HISTORIC AND DESIGN REVIEW COMMISSION

January 17, 2024

HDRC CASE NO: 2023-330
ADDRESS: 919 MASON ST
LEGAL DESCRIPTION: NCB 1267 BLK 3 LOT S 105 FT OF 6
ZONING: R-6, H
CITY COUNCIL DIST.: 2
DISTRICT: Government Hill Historic District
APPLICANT: Juan M Guajardo | By Grace Floors and Construction LLC
OWNER: Rose Galindo
TYPE OF WORK: Wholesale wood window replacement
APPLICATION RECEIVED: August 8, 2023
60-DAY REVIEW: October 7, 2023 (Applicant postponed to January 17th)
CASE MANAGER: Bryan Morales

The applicant is requesting a Certificate of Appropriateness for approval to replace all wood windows at the property.

1 FLOOR PLAN
1/4" = 1'-0"

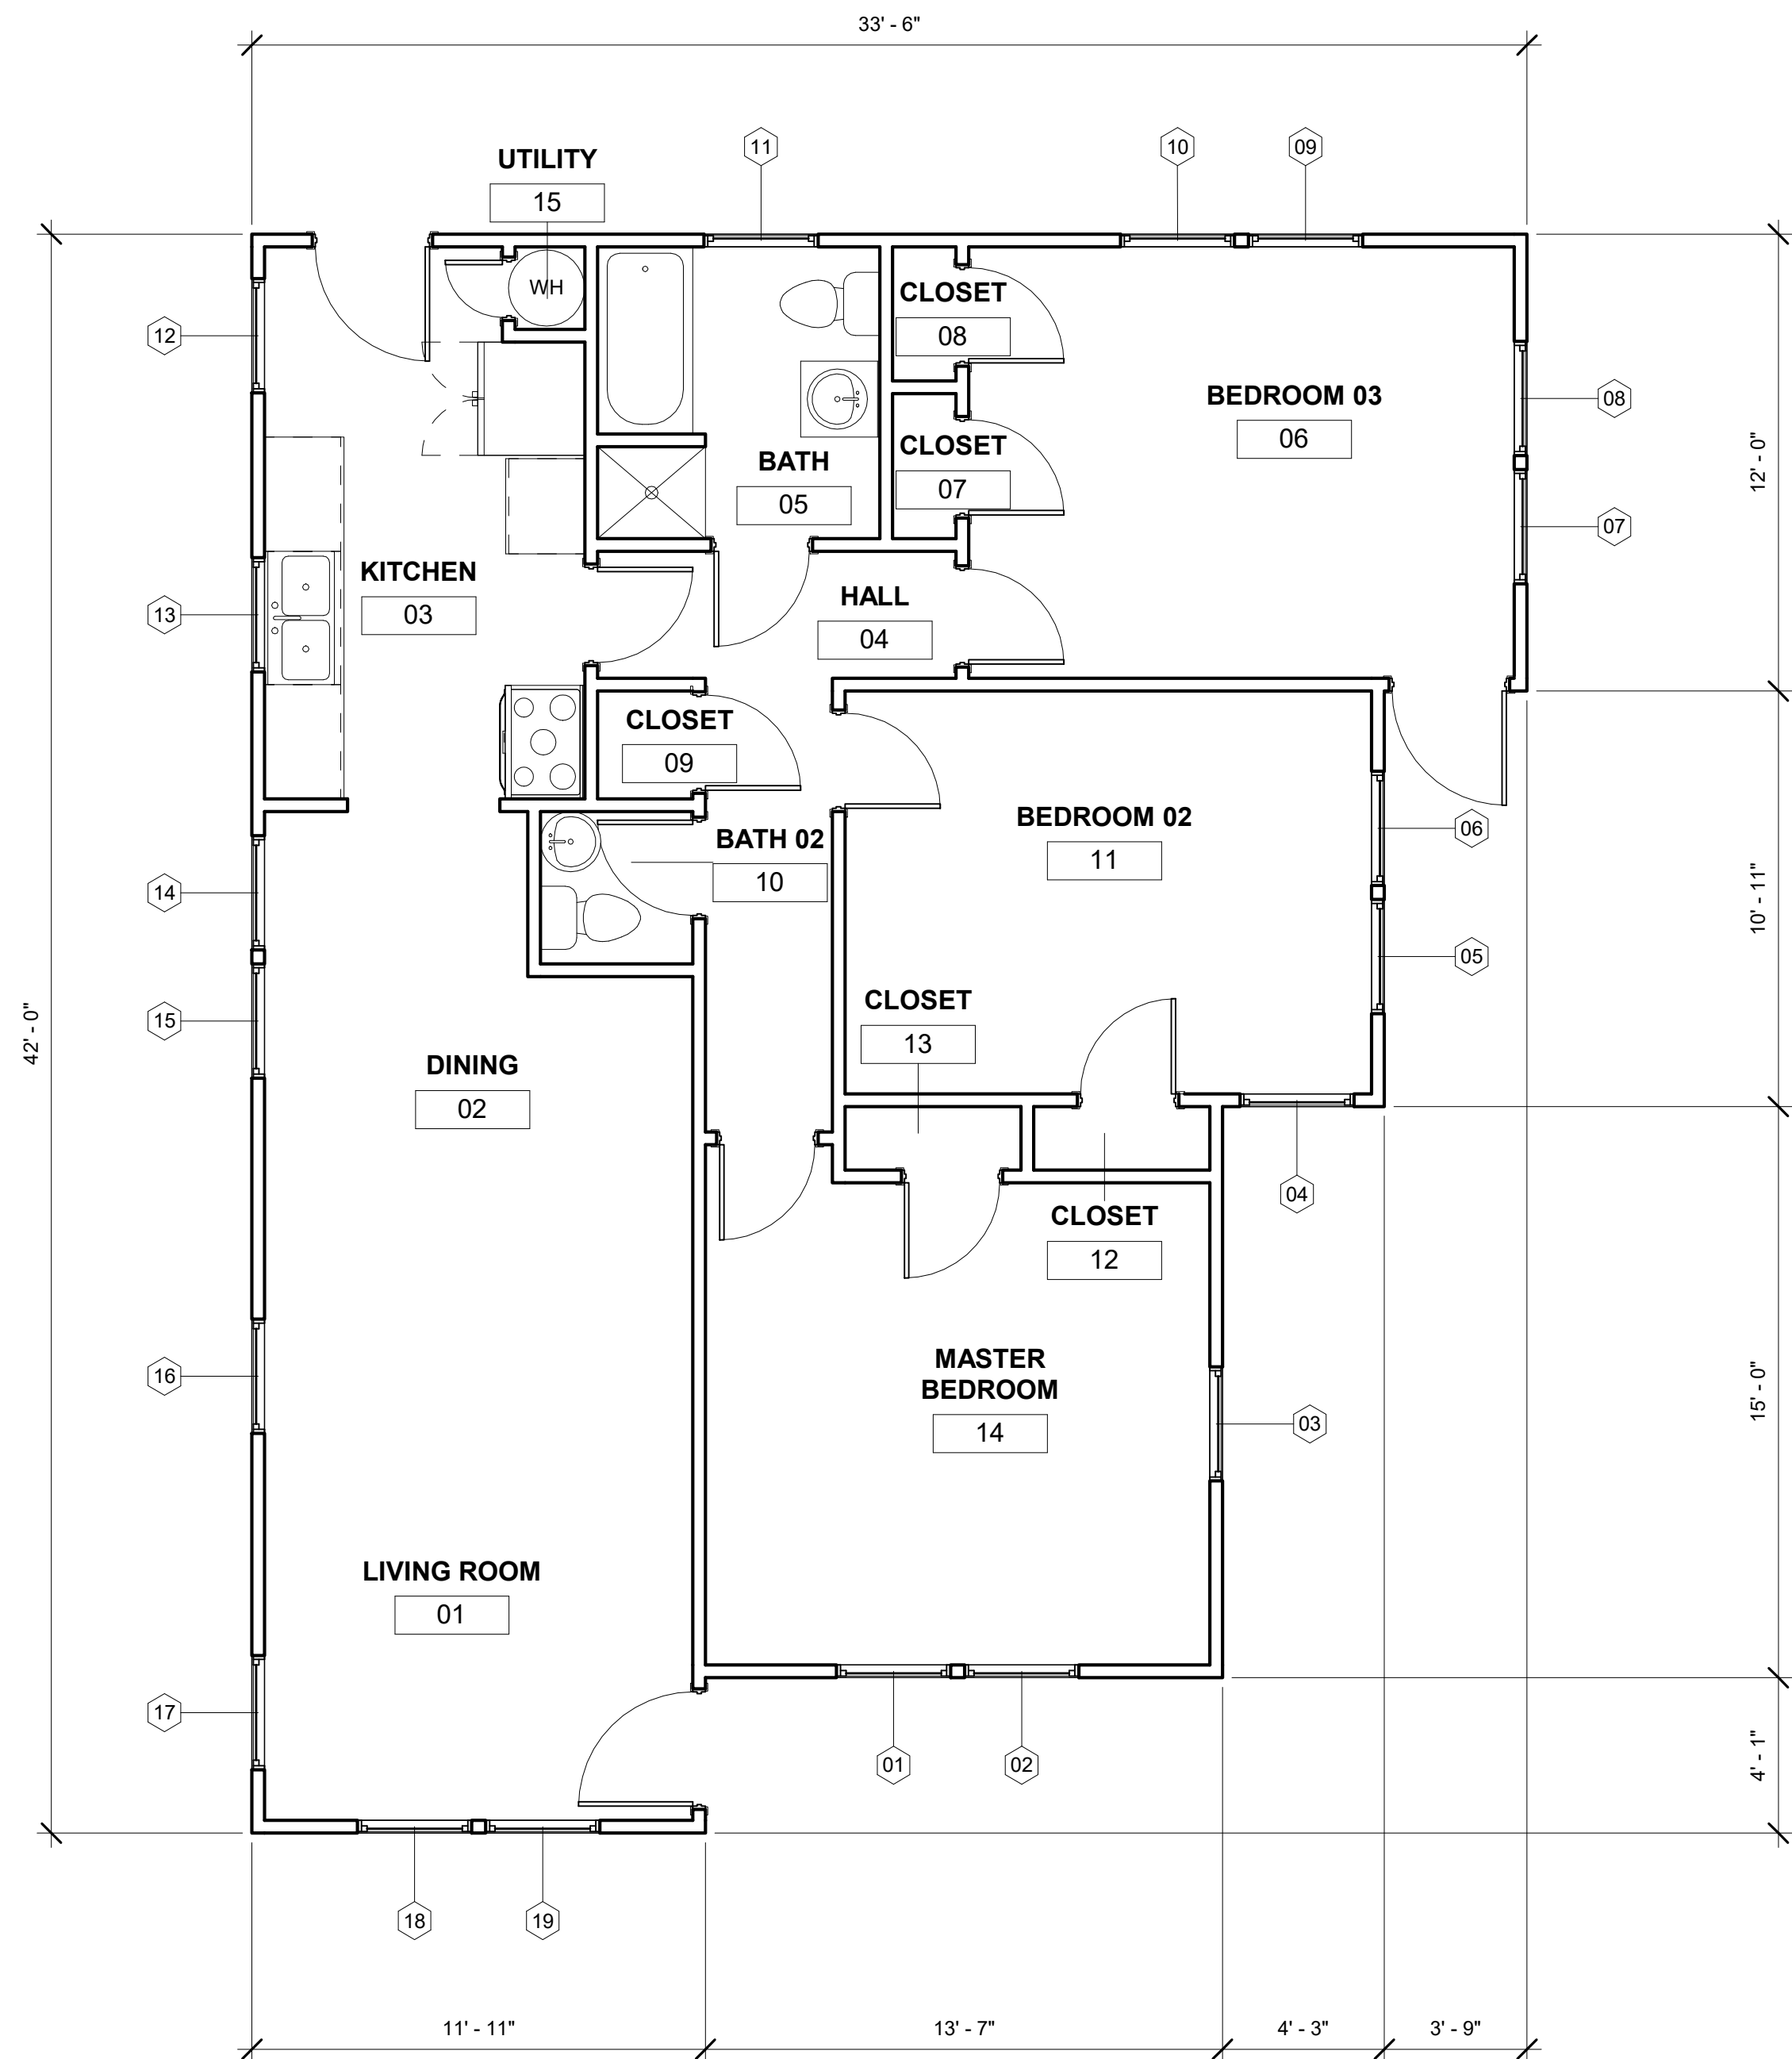
- f. WINDOW REPLACEMENT – The applicant has proposed to replace all existing windows with new wood windows per the submitted window schedule. According to the Historic Design Guidelines, wood windows should be repaired in place and restored whenever possible, unless there is substantial evidence that the windows are deteriorated beyond repair. If a window assembly is deemed irreparable, the window should be replaced in-kind in terms of materiality, configuration, inset, proportion, style, and detailing. As noted in finding c, staff finds windows 1-16 are in repairable condition. Staff does not find replacement of windows 1-16 consistent with the guidelines, but that windows 17-19 are eligible for replacement.

Staff does not recommend approval of the request, based on findings a through f. Staff recommends the applicant work with staff concerning the repair of windows 1-16 and replacement of windows 17-19 in-kind for administrative approval.
